Access Compliance Report

Public Rights-of-Way

Intersection ID: 20645	Main Street: NEWHALL_RD	Cross Street: WINGRAVE_DR	Location: SW
ADA ID: 9A85E3026388	Ramp Type: PerpDiag	Initial Pass/Fail: Fail	Overall Compliance: No
Codes/Mitigation Info/Possible Solution		Field Measurements/Component Compliance

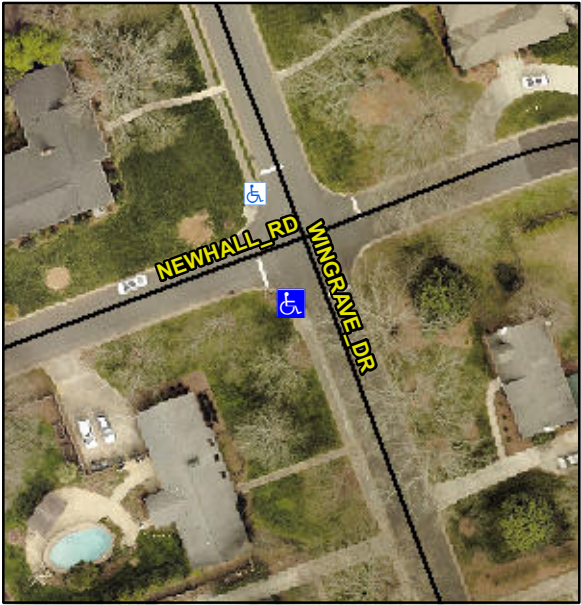
Possible Solutions:						
	Remove & Replace Curb Ramp With Two New Directional Ramps or Equivalent.						
<p>Surveyor Notes:</p> <p>N/A</p>	<p>PROW/ADA:</p> <p>Not Found, R304.5.3</p>	Compliance	Description	Data	Compliance	Description	Data
		N/A	Ramp Length (in)	60.0	Yes	Ramp Slope (%)	6.1
		Yes	Ramp Width (in)	48.0	No	Ramp XSlope (%)	3.6
		N/A	Flare Type LT	N/A	N/A	Flare Type RT	N/A
		N/A	Flare Slope LT (%)	N/A	N/A	Flare Slope RT (%)	N/A
		N/A	Flare Traversable LT?	N/A	N/A	Flare Traversable RT?	N/A
		N/A	Landing Length (in)	N/A	N/A	DWS Provided?	N/A
		N/A	Landing Width (in)	N/A	N/A	DWS Contrast?	N/A
		N/A	Landing Slope (%)	N/A	N/A	DWS Length (in)	N/A
		N/A	Landing X Slope (%)	N/A	N/A	DWS Full Width?	N/A
		N/A	Landing Curb? (Y/N)	N/A	N/A	DWS Offset (in)	N/A
		N/A	Shared Landing?	N/A			
		N/A	Gutter Ponding?	N/A	N/A	Gutter Slope (%)	N/A
		N/A	Gutter Lip Ht (in)	N/A	N/A	Gutter X Slope (%)	N/A
		N/A	Painted X Walk1?	No	N/A	Painted X Walk2?	No

X Walk 1 Direction	To E		X Walk 2 Direction	To N
		N/A	X Walk 1 Width (in)	N/A	N/A	X Walk 2 Width (in)	N/A
			X Walk 1 Slope (%)	3.0		X Walk 2 Slope (%)	4.8
			X Walk 1 X Slope (%)	4.1		X Walk 2 X Slope (%)	1.3
		N/A	Ramp inside XWalk1?	N/A	N/A	Ramp inside XWalk2?	N/A
			Road Slope (%)	1.2	N/A	Clear Space?	N/A
			Road X Slope (%)	11.3	N/A	Clear Space to XWalk (in)	N/A
		N/A	Any Obstructions?	N/A	N/A	Storm Grate/Utility Hazard?	N/A
			Obstruction Type			Storm Grate/Utility Type	
					N/A		N/A
					Yes	Surface Condition? (G/P)	Good
